Dear M/s Tozer,

I am aware that you have had very few working days to explore this application, and that only another five will pass before the close of consultation. Given the very challenging nature of the site and application, in the words of the WHSAP Examination, I have compiled the following to hopefully aid your work. The site has gone through Examination, Committee, and Public Inquiry, with each stage layering commitments onto the applicants (whether that be Waddeton Park, Savills or now Wain Homes). I hope that a summary herein will help to “short-circuit” the past nine years of stress-testing and conditioning which have formed the framework of a compliant and sustainable application. When these conditions are taken into consideration, it is clear that this application as submitted is neither compliant nor acceptable.

In the current application, the bridge length has been reduced, leading to the termination of the bridge and the ONLY access point being within Flood zones 1,2, and 3. As illustrated here from Planning layout sheet 2.

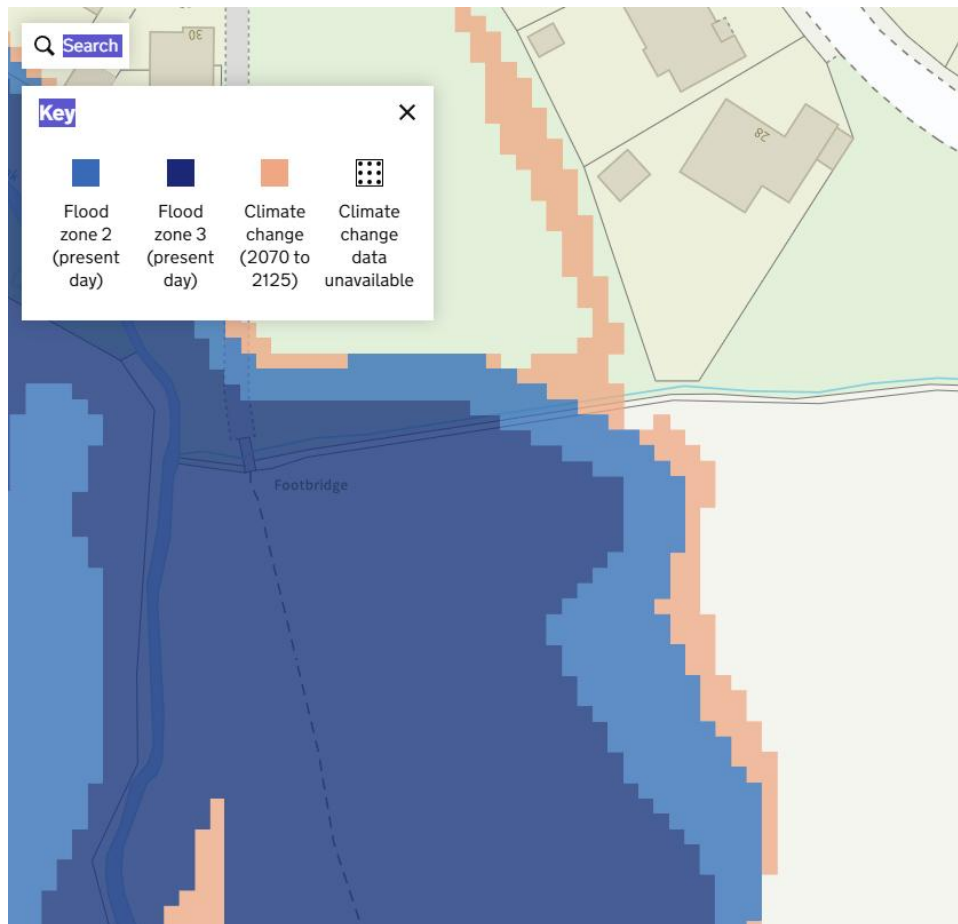
3. Access to the site, and the only element of the Outline application agreed, is from the Frome Road (AKA Firs Hill Road). This access is by means of a feeder road and junction approximating .75km. The access road terminates at a designated flood zone encompassing levels 1, 2, 3a and 3b, level three flood designations being the most severe which can be applied at any point in the country under current legislation. The original argument for the access was the construction of a bridge and culvert across the notified flood zones. At the time of Public Inquiry the requirements for this bridge were a length of 100m and

It should be noted that Flood Zone one has been omitted from this illustration, and also that curtilage and access for a number of units also falls within this designation, itself a further breach. Furthermore, the data on which this application is submitted is out-of-date and underestimates the situation. By focussing in on the area using the latest iteration of the Environment Agency Flood Map for Planning, and using the Lambrok and footpath as reference points, the extent of the Flood Zones have been significantly understated. This extends the inviolable FZ3 well into the new build.

Again, this disregards the additional surface water being added to the fluvial flow by the current proposal, making this data point doubly unreliable.

This renders the application in breach of National requirements regarding development on a flood plain, and unsustainable in its current form. The sole answer is to require the bridge and culvert to span the entirety of the flood zones, and in a greater length than the 100m first proposed and agreed to allow for the climate change modelling. To be clear, the entire proposed layout is untenable and must be sent back for compliant revision.

Figure 1. Core bat habitat feature, and associated buffer zones indicated for both development boundary features (above) and within development features

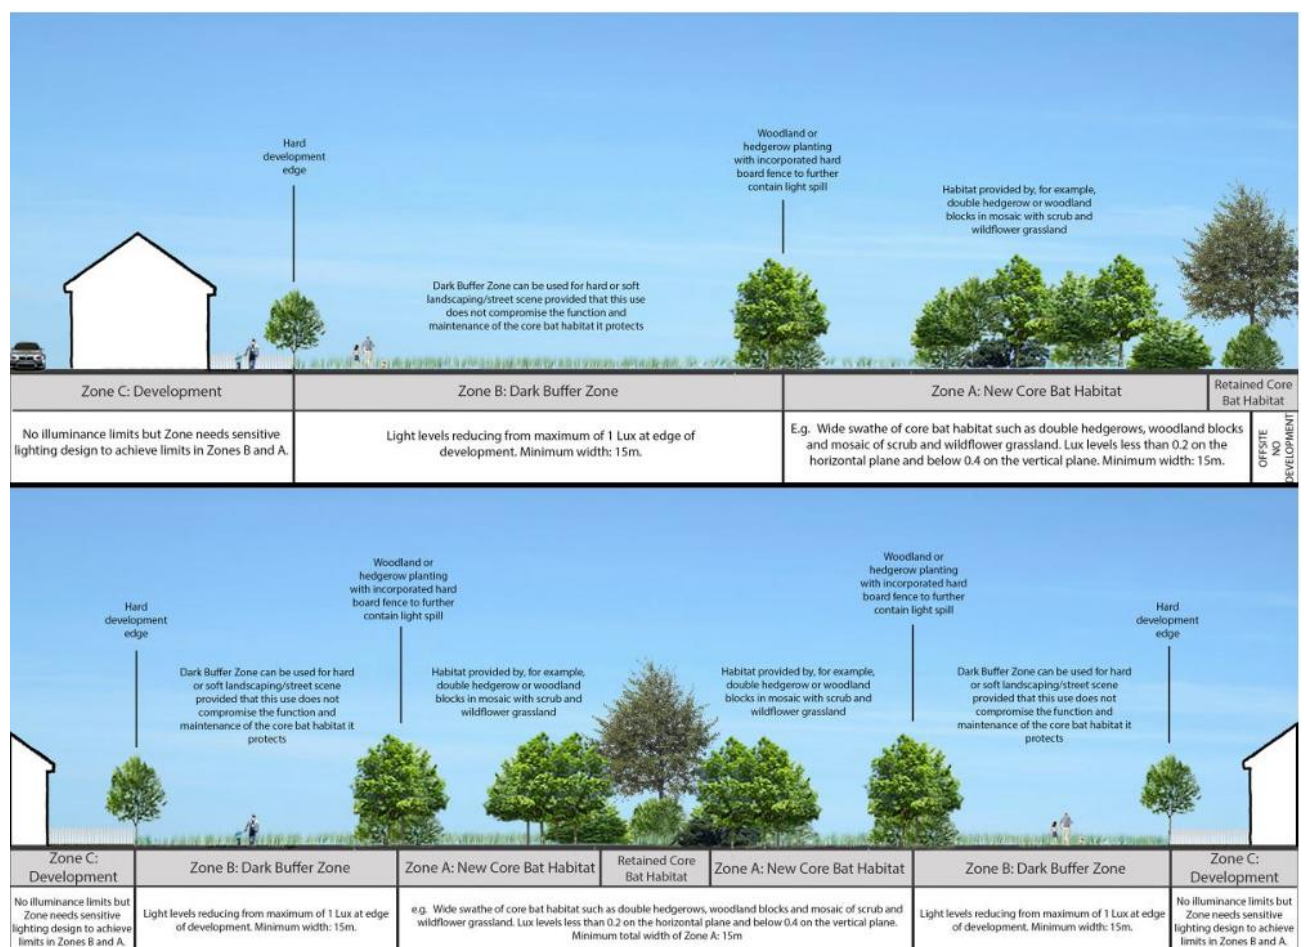
A cursory glance at the above, alongside comparison with the application shows:

- No planted boundary at the perimeter of Zone A.
- No hard-boarded fence at the perimeter of Zone A associated with the planting.
- No “mosaic of scrub and wildflower grassland”.

The detail in the application fails to deliver any of the above, suggesting wildflower alone will meet the requirements of the Policy/planning document. In parts of the application area not even this rudimentary condition is met. In the area running along the Lambrok, which must be in accordance with the lower illustration, this condition is breached twice with the multiple disregard of the hard-boarded fencing at the perimeter of both Zone A perimeters.
